Regional Joint Development Assessment Panel Agenda

Meeting Date and Time: Friday, 27 October 2023; 9.30am
Meeting Number: RJDAP/119
Meeting Venue: Electronic Means

Development Description:	Proposed Motor Vehicle Sales and Motor Vehicle Repair
Applicant:	Hidding Urban Planning
Owner:	5 Barnard Pty Ltd 6 Barnard Pty Ltd
Responsible Authority:	City of Bunbury
DAP File No:	DAP/23/02463

SITE & GROUND FLOOR PLAN
SCALE: 1 : 200

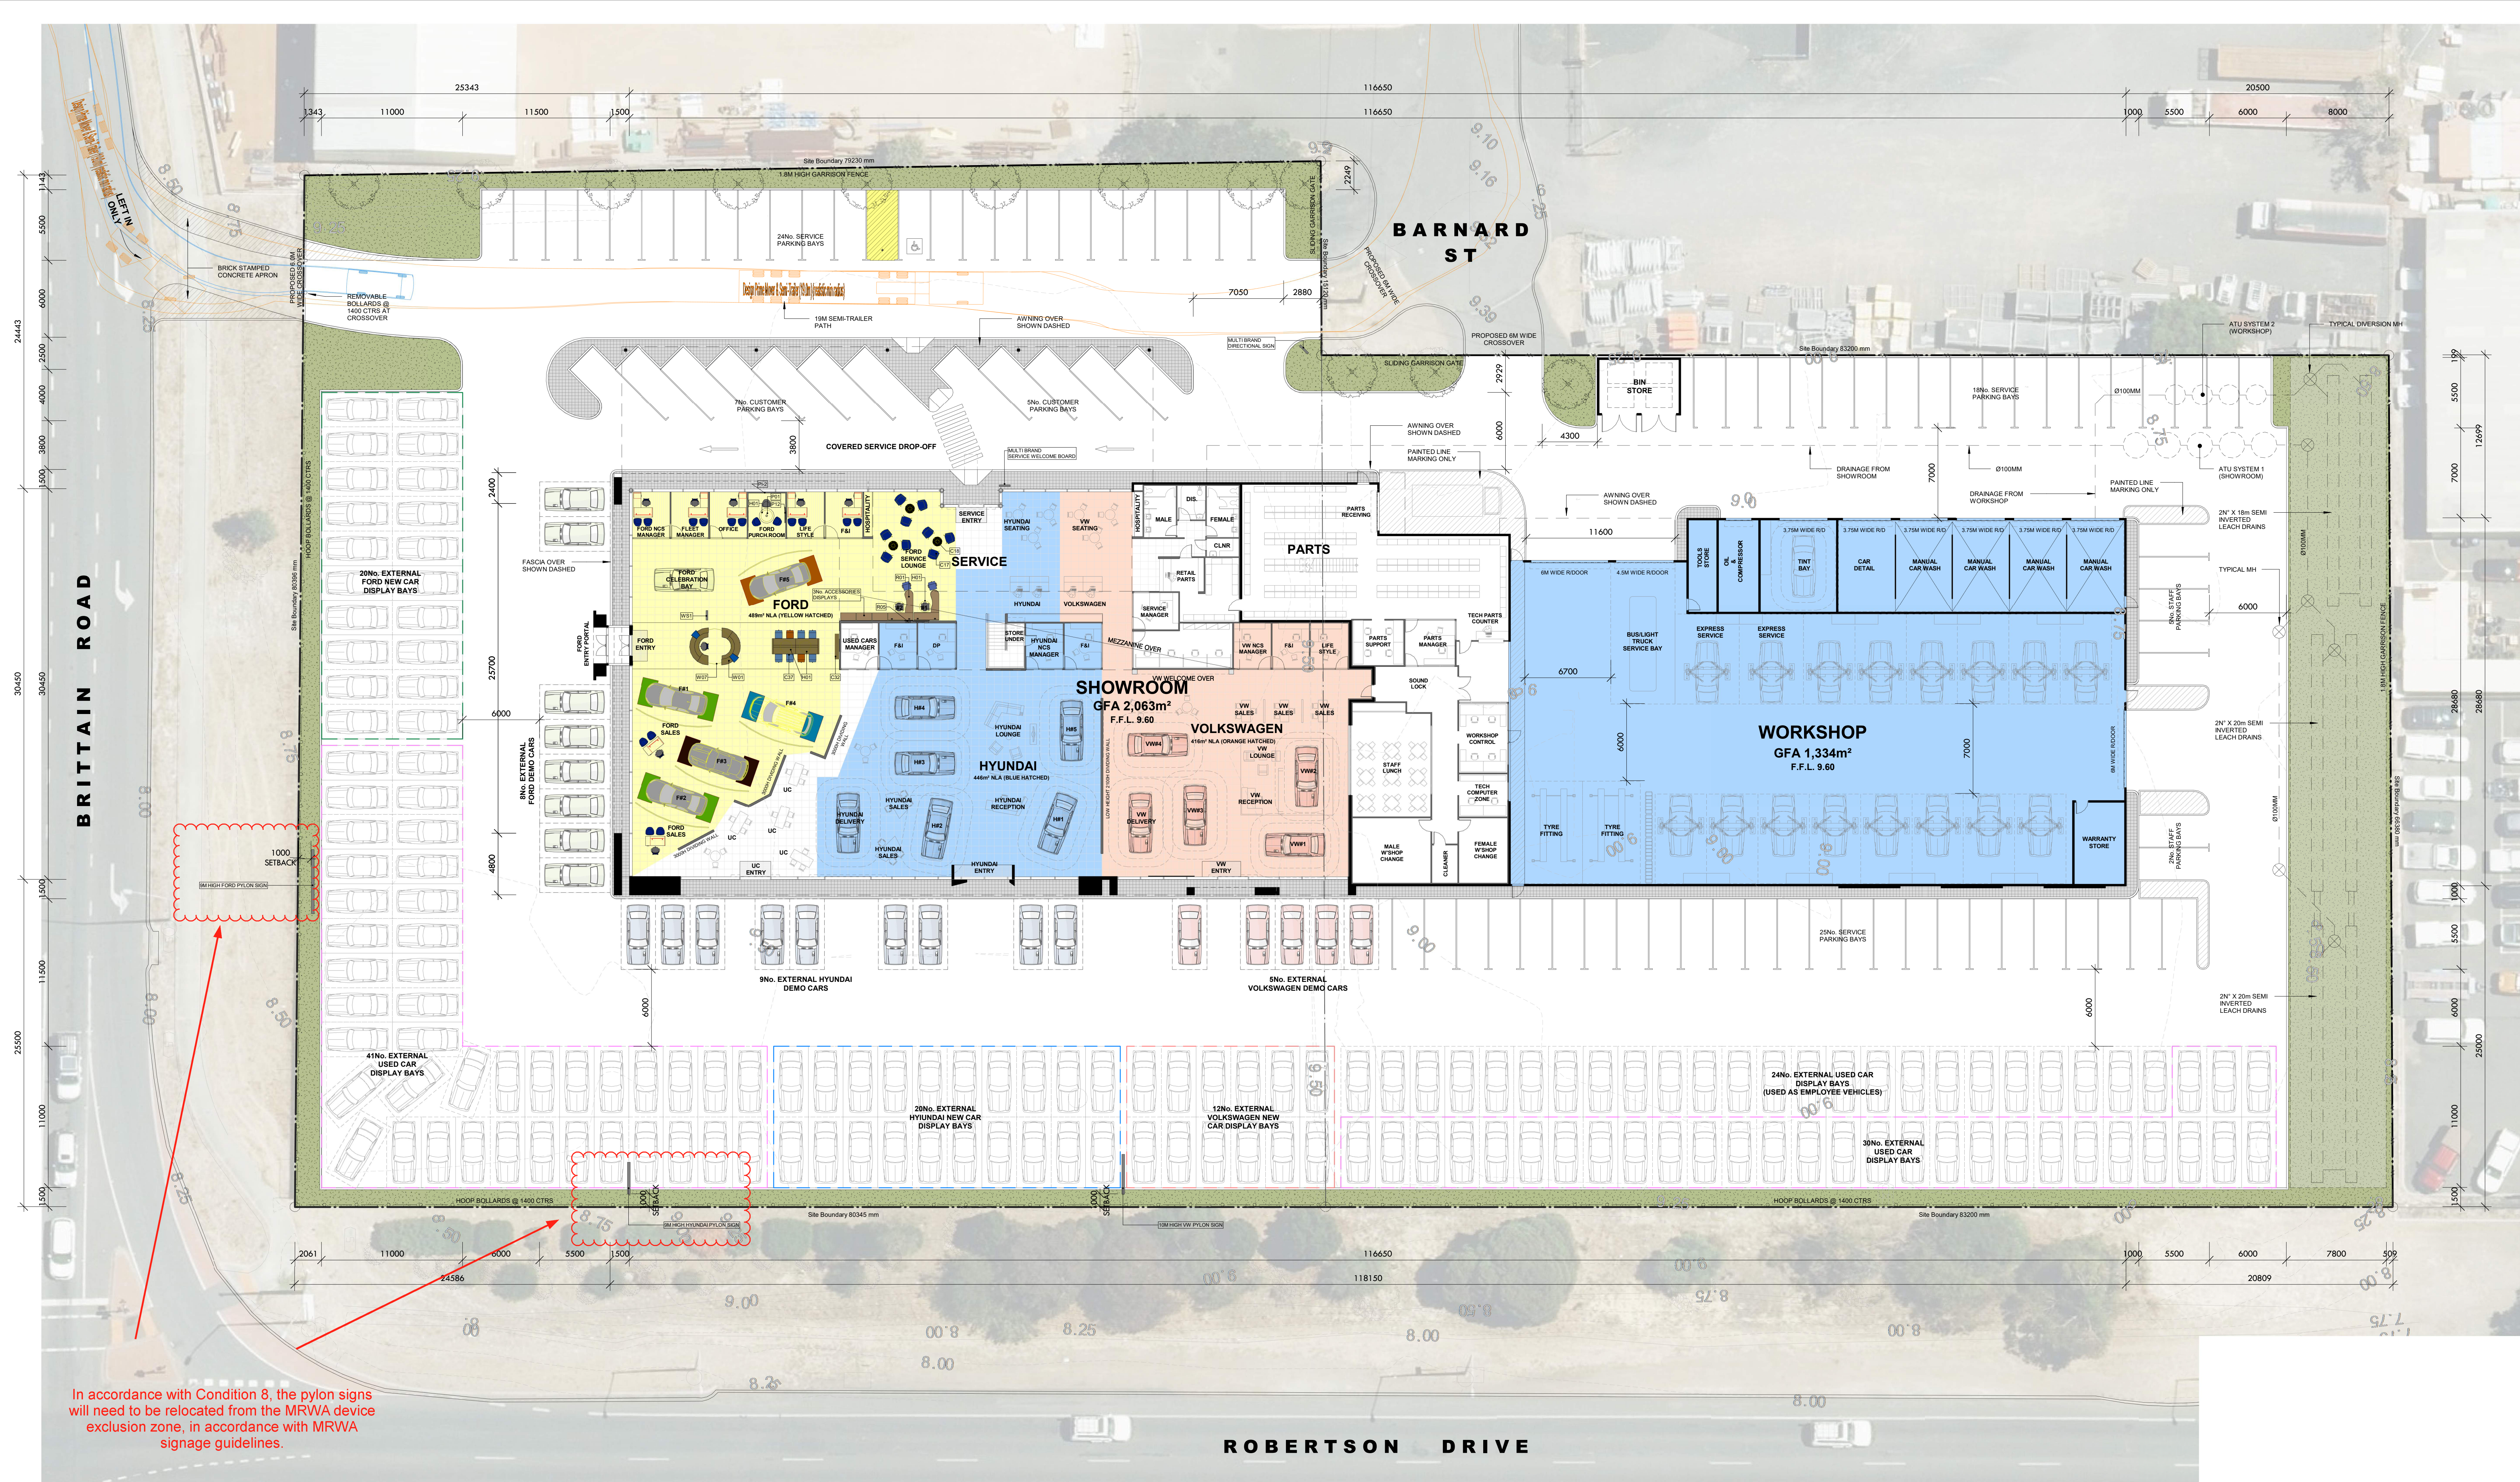
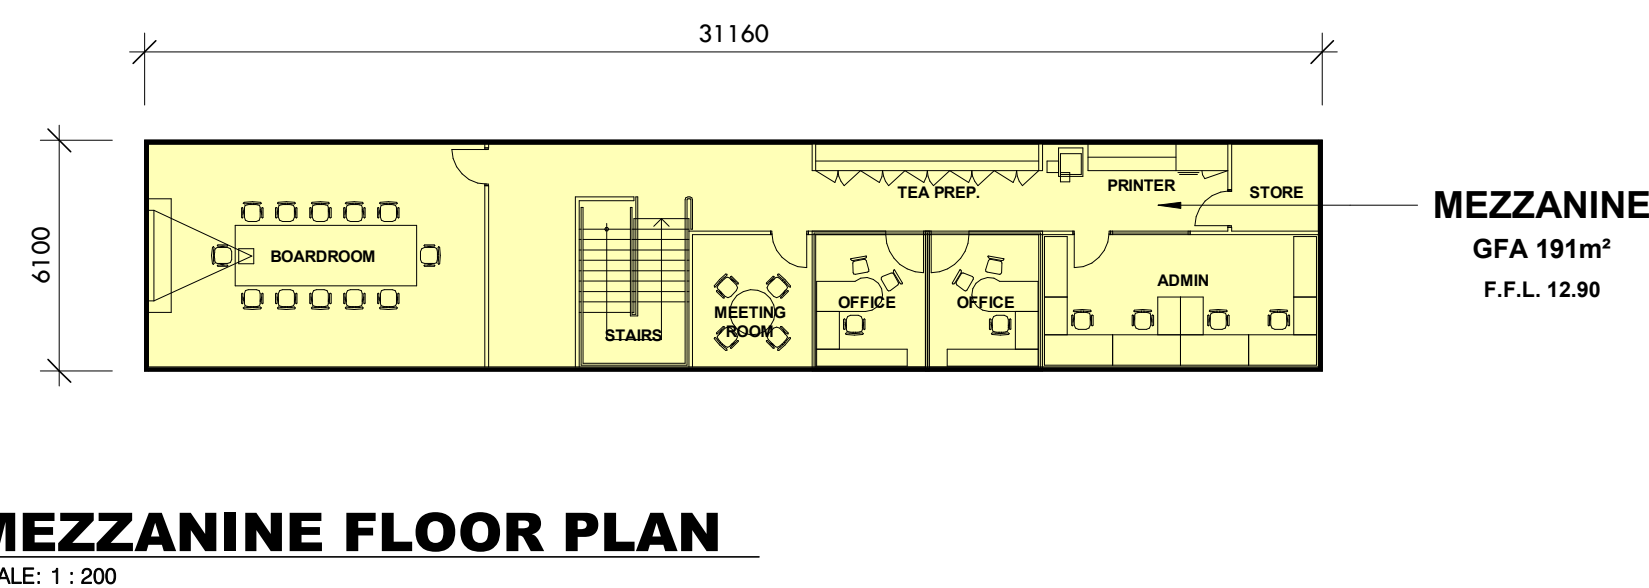
In accordance with Condition 8, the pylon signs will need to be relocated from the MRWA device exclusion zone, in accordance with MRWA signage guidelines.

8. Prior to the submission of a building permit, an amended signage location plan shall be submitted to the City of Bunbury for approval. The pylon signs shall be limited to a maximum height of 7.2m above natural ground level.
9. The maximum luminance level of the electronic graphic display screen sign is not to exceed 500 candelas per metre square (cd/m²).
10. Signage is not to flash or pulsate and shall be of an illumination level that is suitable to off-street ambient lighting.
11. The sign shall be professionally made and kept clean and maintained free of dilapidation at all times.
